# SVI New Product Notice . . .

May 5, 2006

## Improved seals for use on in-ground Rotary Lifts.

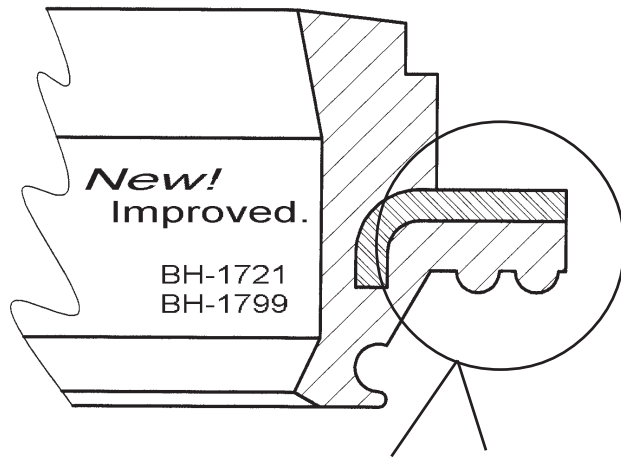
**Original version had smaller static seal ribs, which may not adequately seal on the casing flange of older lifts that exhibit bearing wear and plunger play.**

**Larger, wider static seal ribs vastly improve the performance specifically on older Rotary lifts with worn bearings and plunger play.**
